Planning Commission Meeting Agenda
Hartland Township Hall
Thursday, November 07, 2019
7:00 PM

Submitted By: Troy Langer, Planning Director
Subject: Site Plan #19-009 Burger King Remodel
Date: October 31, 2019

Recommended motion for Site Plan Application #19-009 (Burger King Remodel)

IP# 2019.2190
CC# 1019
BK 5118
10382 HIGHLAND RD.
HARTLAND, MI 48933
DATE: 06.06.19
BK-2500
ROOF PLAN
A-1.2
CHECKED: DA
DRAWN: MM
28

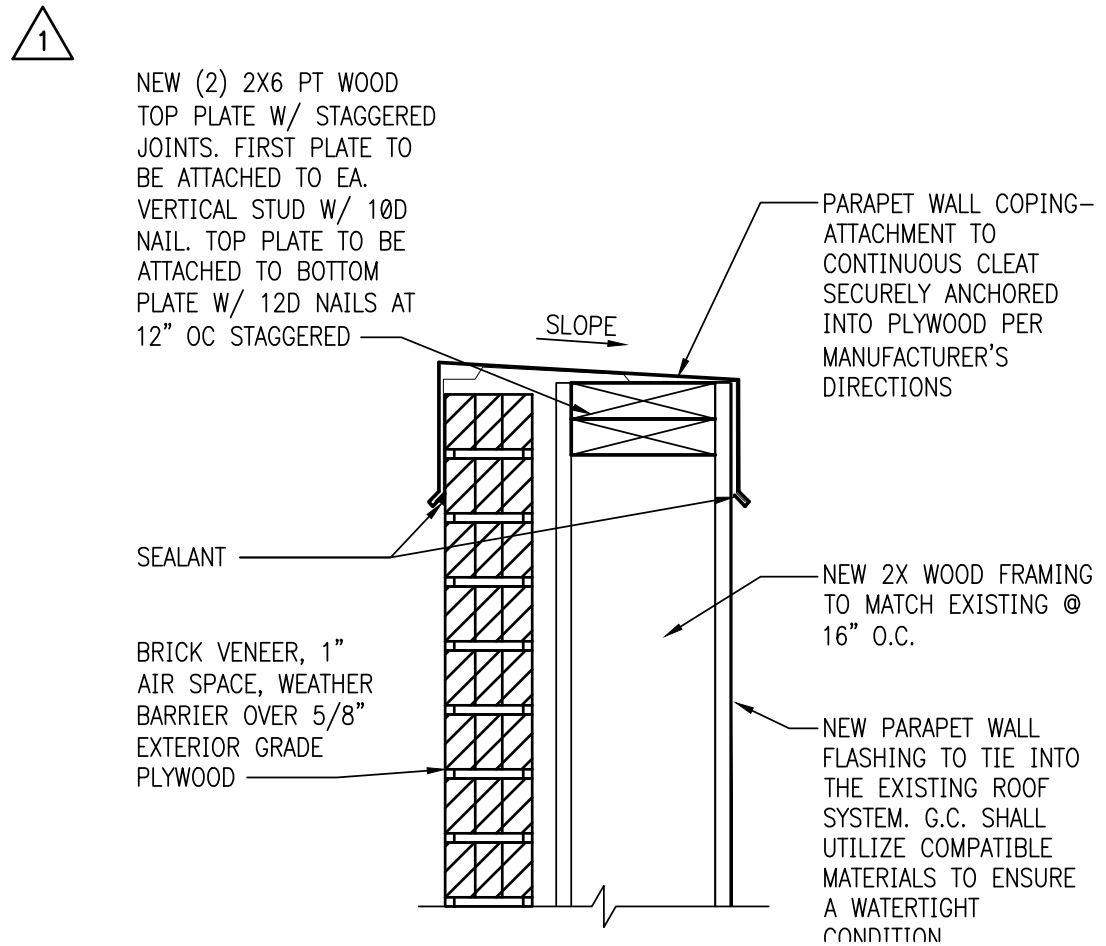
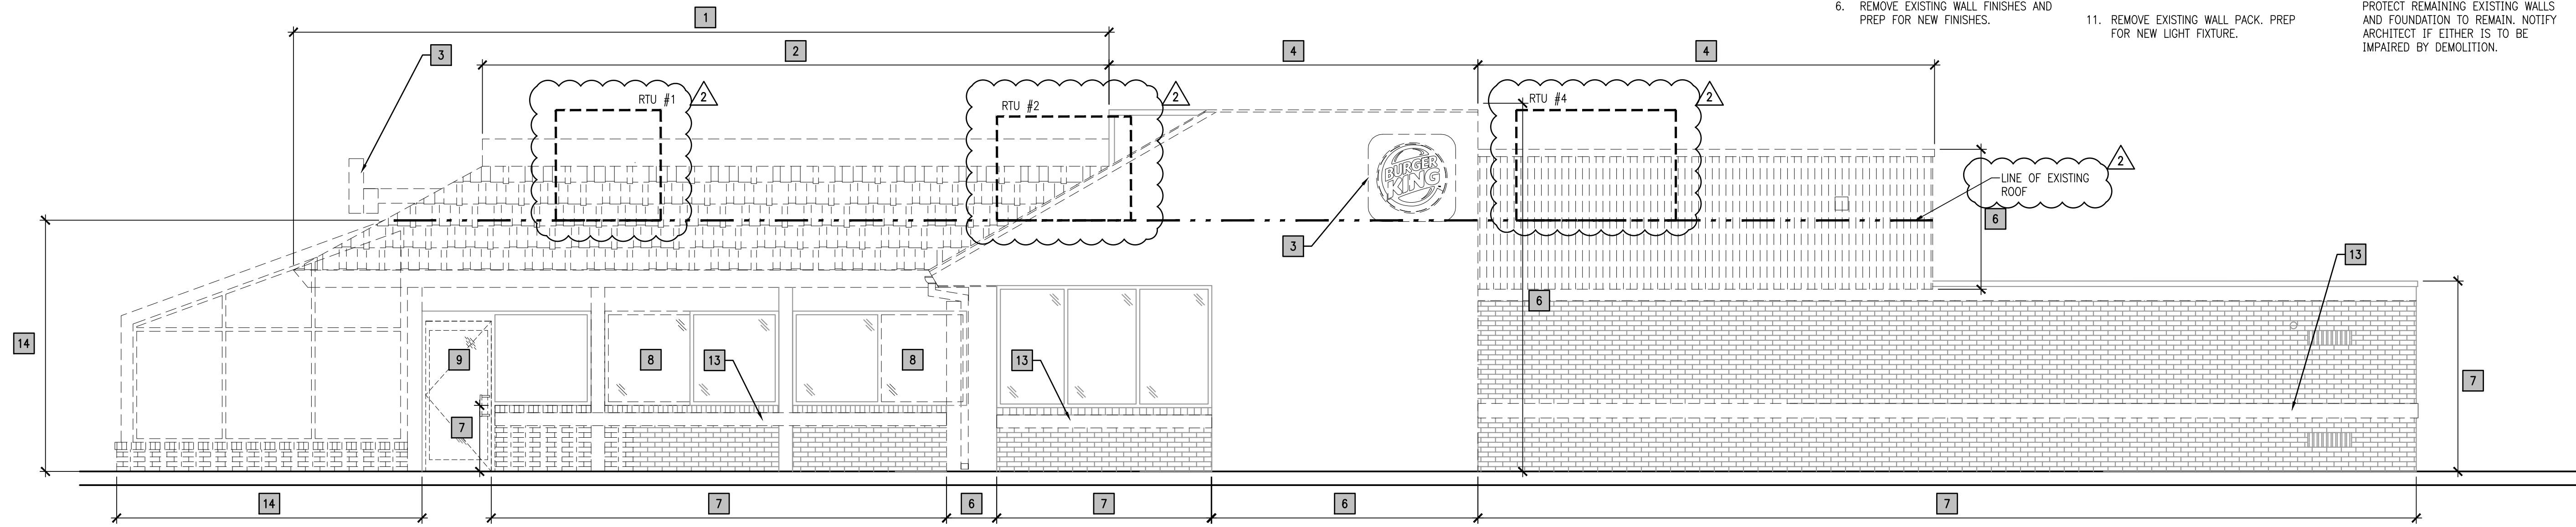
Sheet A-1.2 (Interplan set of plans) includes references to a new light band to be installed on the proposed parapet walls. A light band is similar in nature to outline tubing/neon sign which is listed as a prohibited sign per the Sign regulations in the Zoning Ordinance (Section 5.26). All light band references should be removed from the plans.

Also to be noted, the applicant has provided revised elevation drawings, dated October 29, 2019, showing the physical roofline and the outline of each rooftop unit. The four (4) rooftop units are shown in plan view on the first sheet.

1 MAIN ENTRY ELEVATION - DEMO
SCALE: 1/4" = 1'-0"

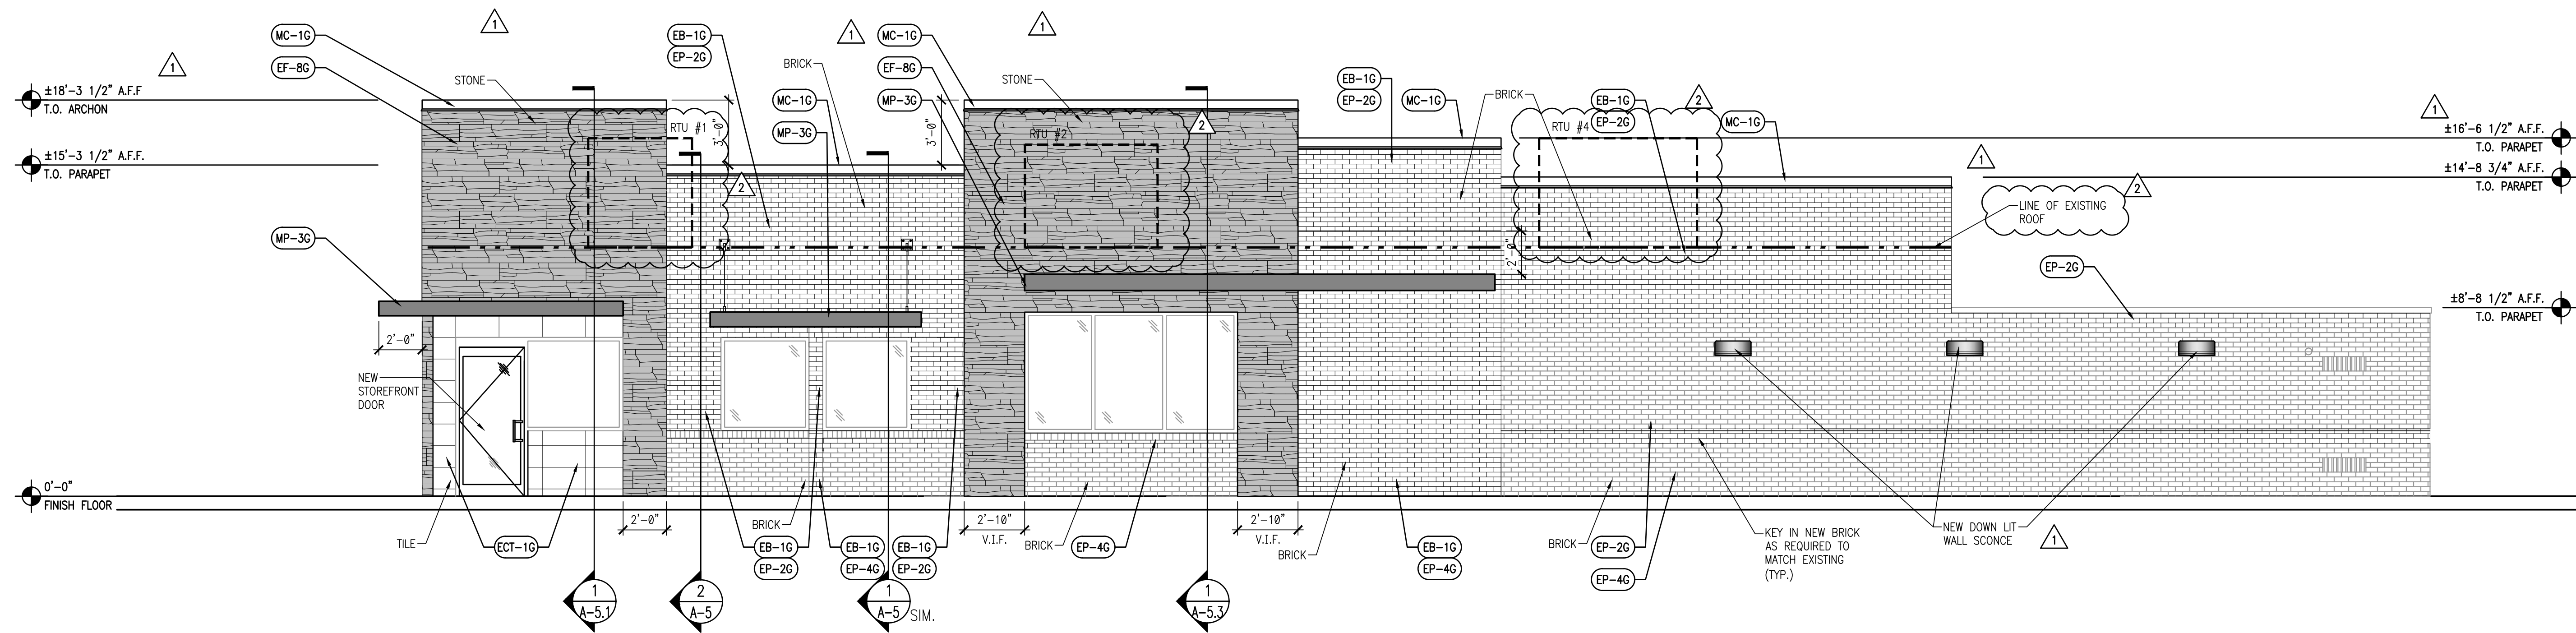
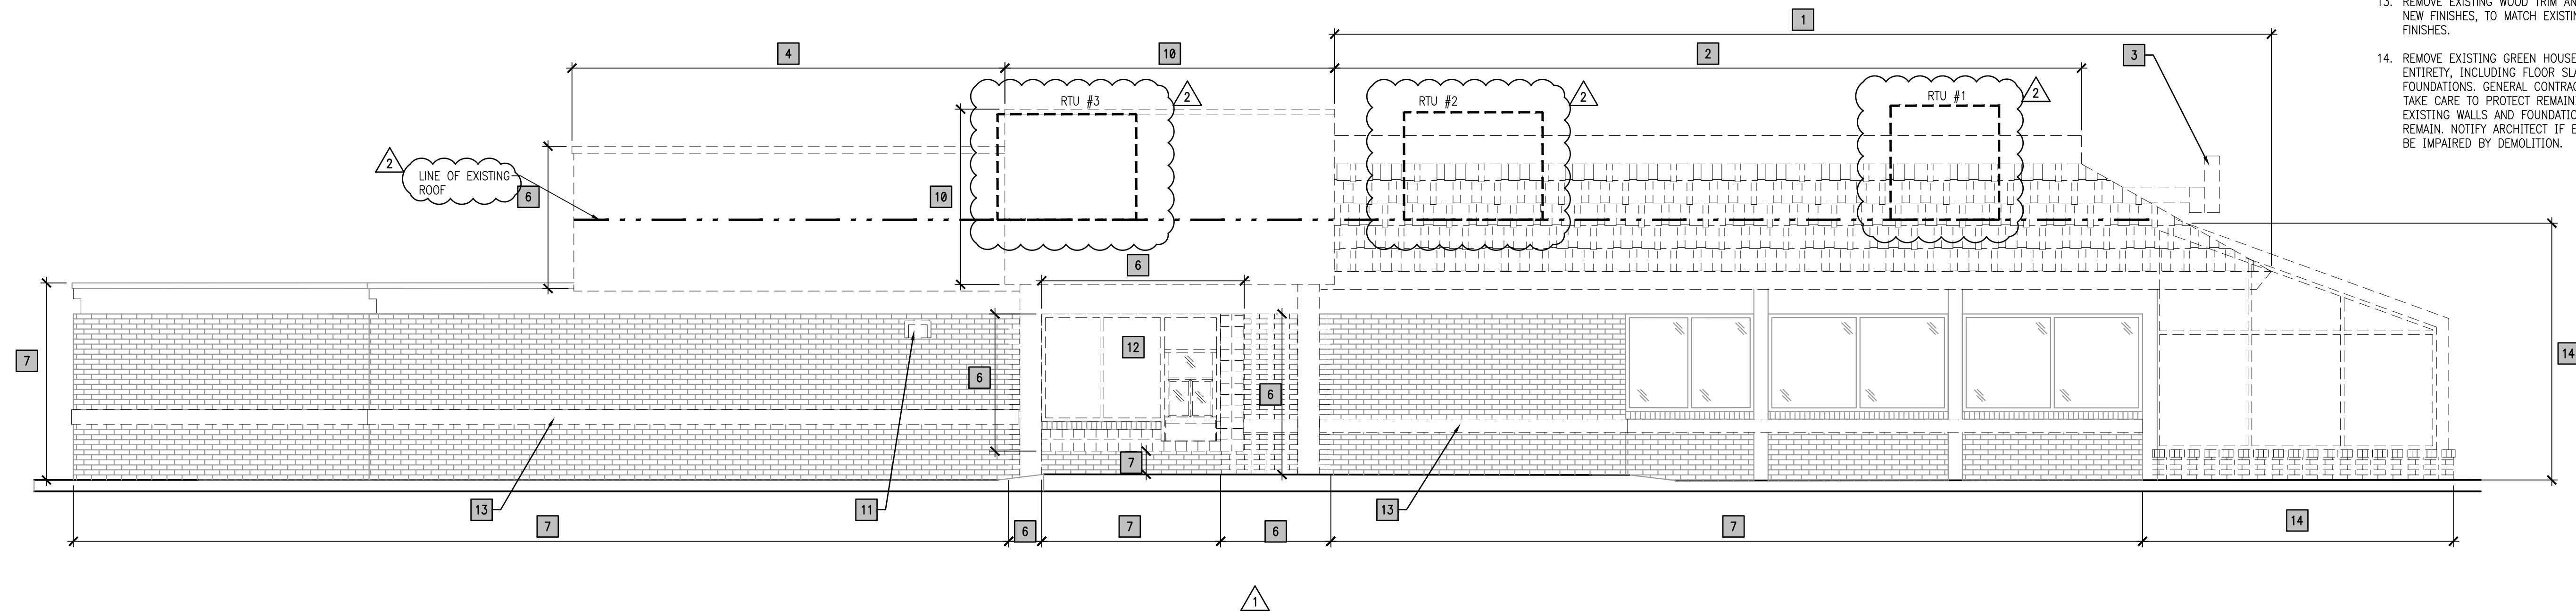
As staff reviewed the plans provided by Interplan, it was noted that the product and color designations stated on the scaled building elevations (Sheet A-3.0, A-3.1, and A-3.2) and the Exterior Materials &

Finishing Schedule (Sheet A-4.0), do not match the information on the color version of the building elevations. Staff spoke with the applicant about this matter and he responded that the construction set of drawings would be revised so that the specific product name and color are consistently listed on all relevant sheets.

The applicant has provided an email, dated October 30, 2019, stating the rooftop units will be screened as required per the Ordinance regulations in Section 5.24.4., by raising the parapet wall heights and using the same proposed exterior finishes. This is required for all four (4) sides of the building. Revised elevations will be required with the construction set of plans that show the parapet wall being extended, on all four (4) sides, to sufficiently screen all rooftop equipment, using the same exterior finishes. The percentage of each façade material for each elevation should also be revised and shown on the plans.

planting detail

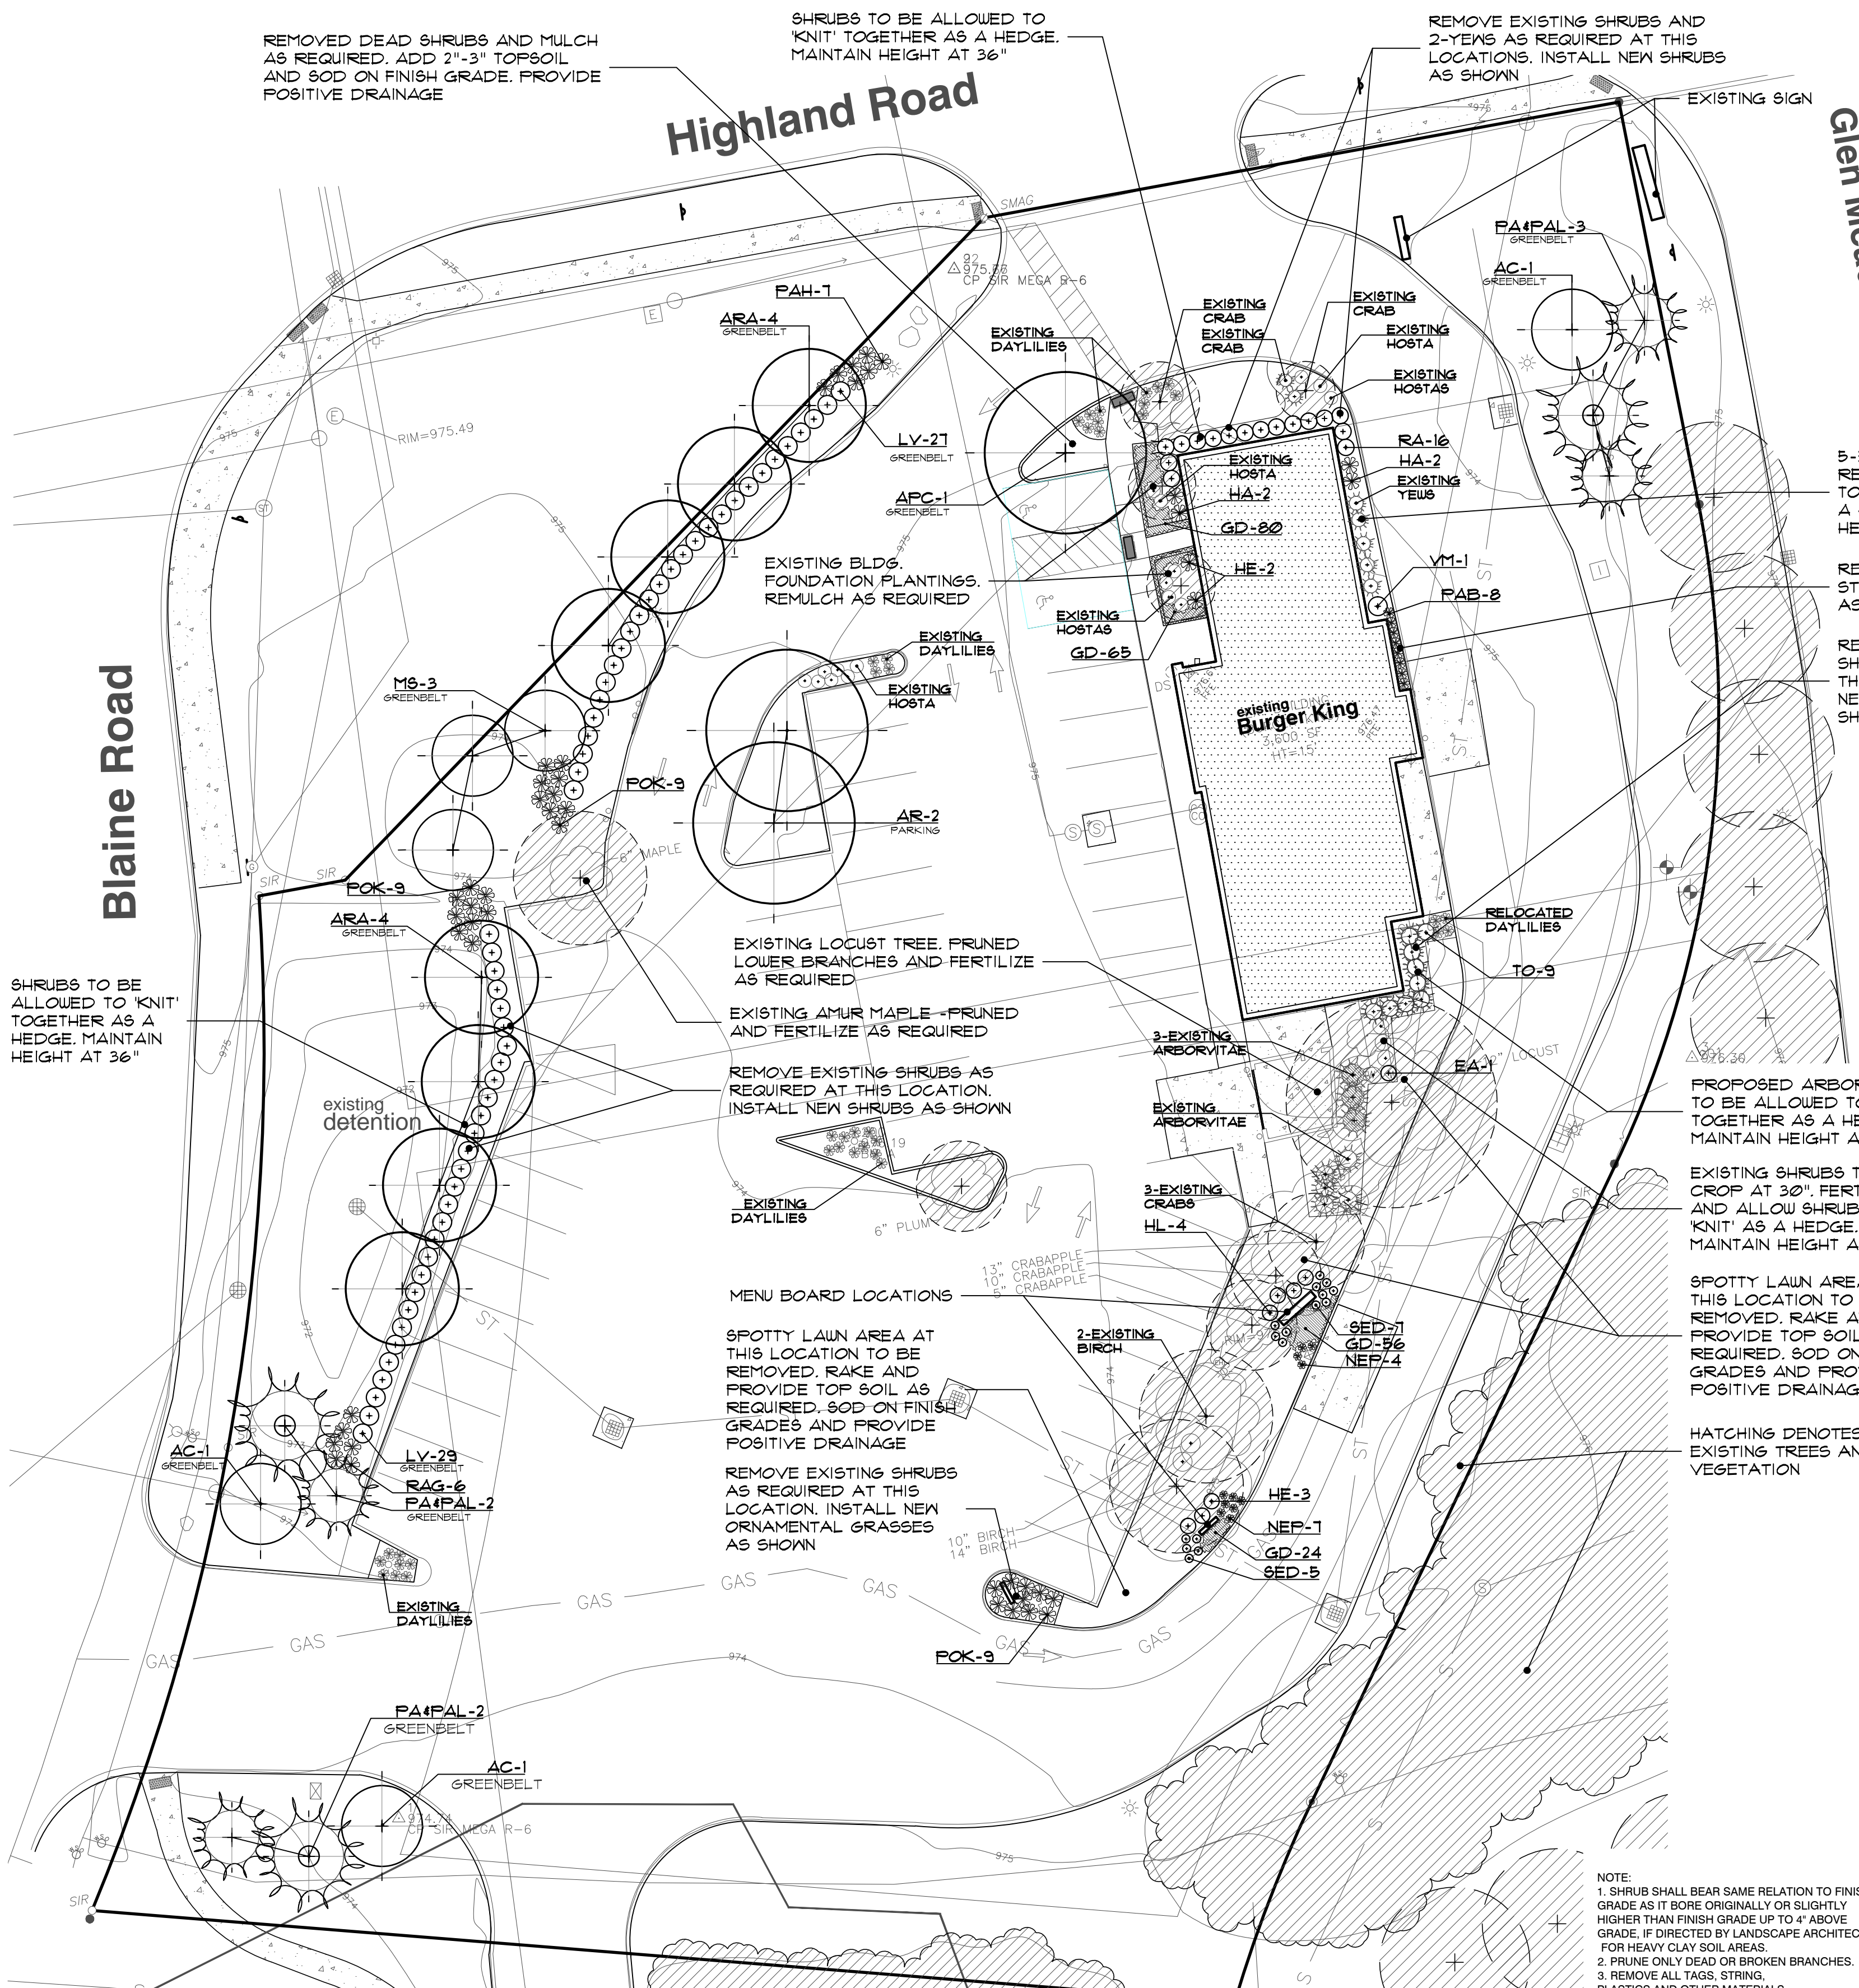
A landscape plan was submitted showing existing and proposed landscaping. As a reminder, the landscape plan does not show the building footprint correctly, as the greenhouse portion is still shown; thus the landscape plan will have to be revised.

Currently deciduous shrubs (9 shrubs) are planted along the west side of the parking lot which are to be removed per the proposed plan. A deciduous shrub hedgerow is proposed. An evergreen screen of the parking lot is required in this area, thus an evergreen shrub species (3-foot tall) should be used in place of the proposed deciduous shrub. Staff would recommend using a salt-tolerant evergreen shrub species.

A 3-foot high evergreen screen is required for the parking island at the northwest corner of the building. The plan shows lawn and daylilies; therefore the plan should be revised to comply.
